Supplemental Responses to Request for Additional Information – Revised November 29, 2021
Certificate of Compliance No. 1032
Docket No. 72-1032
HI-STORM FW Storage System
Amendment No. 6

Structural RAI-3-1 (dated 11/6/2020)

The following figure show the comparison between the material flow curves for a typical stainless-steel 304 material using 2 distinct approaches, as follows:

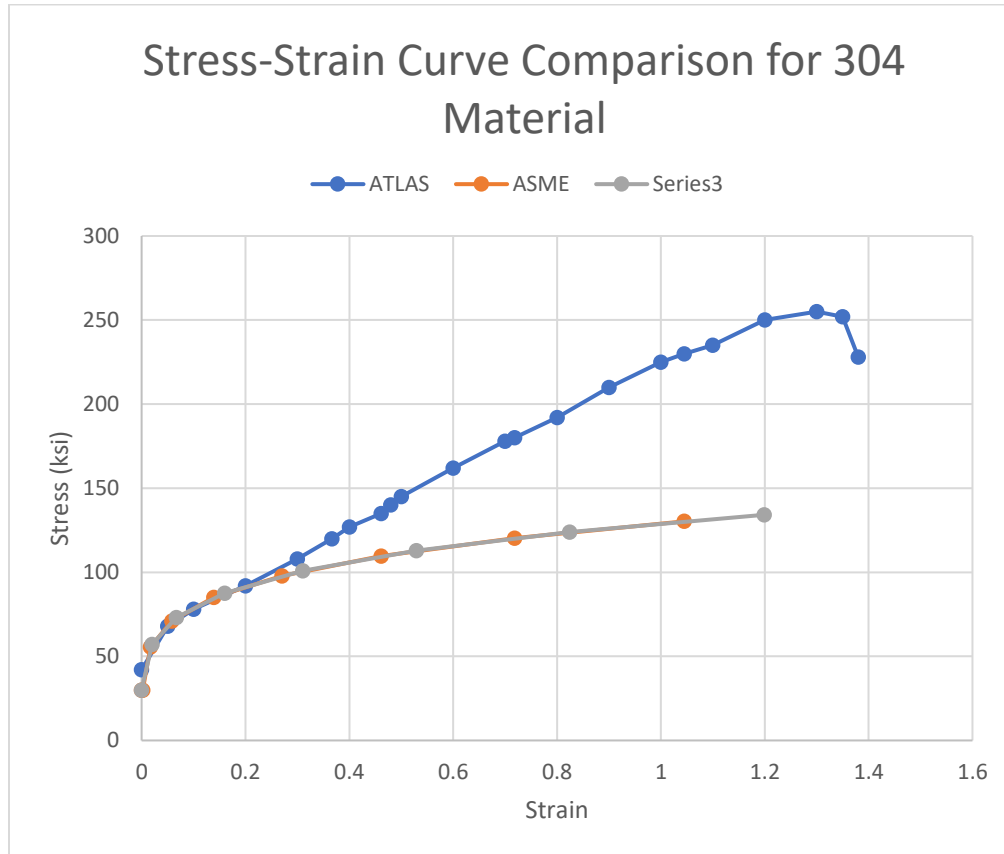
The methodology used in Appendix B to Holtec Report HI-2200647 to compute material flow curves for the finite element structural analysis and strain-based evaluations follows the Holtec Position Paper DS-307, "Construction of True-Stress-True-Strain Curves for LS-DYNA Simulations." The staff notes that the use of the methodology outlined in this position paper has previously been found inadequate to provide material data for strain-based evaluations, in particular for an evaluation of the ATB 1T transportation package. Specifically, constants used to develop material flow curves have been determined analytically (e.g., constants "K" and "n") without the support of material testing. As discussed in the summary of the November 13, 2018, meeting with Holtec International (ADAMS Accession No. ML18331A184), the staff's position is that these constants should be based on mean test values obtained from material testing. In addition, the applicant needs to supply material flow curves that consider strain-rate effects, uniform elongation, and triaxiality effects if the material is challenged beyond the uniform elongation limit.

As the mechanical property data is essential to the validity of the structural analysis of the drop accident condition, the staff requests that the material models used in the LS-DYNA simulations described in Holtec Report HI-2200647 be based on sufficient physical testing and any results be updated.

The constants used to develop material flow curves (e.g., constants “ K ” and “ n ”) are not arbitrary “guessed” values. The values of K and n are computed using an iterative solution method implemented in Mathcad to find the converged solution, which requires an initial guess value. The final converged values of K and n are mathematically accurate and consistent with the underlying material properties (i.e., S_y , S_u , elongation, % reduction of area). See the response to RAI 5-21 from HI-STORE application (Docket # 72-1051) for more detailed information (which was recently submitted on November 20, 2020).

Accordingly, the HI-STORM drop simulation performed in support of this amendment use the minimum ASME material properties to develop the true-stress-vs-true strain curves. The actual test properties (Certified Mill test Report) generally show the material strength properties to be higher by approximately 15%. This is substantiated in the following paragraph.

- a. ASME minimum strength properties
- b. Atlas-stress and strain curves [Ref-2]

It is clearly noted that the curve developed using the ASME minimum properties, which is the basis for the licensing analysis in support of this amendment, is lower than the curve obtained from the other two sources.
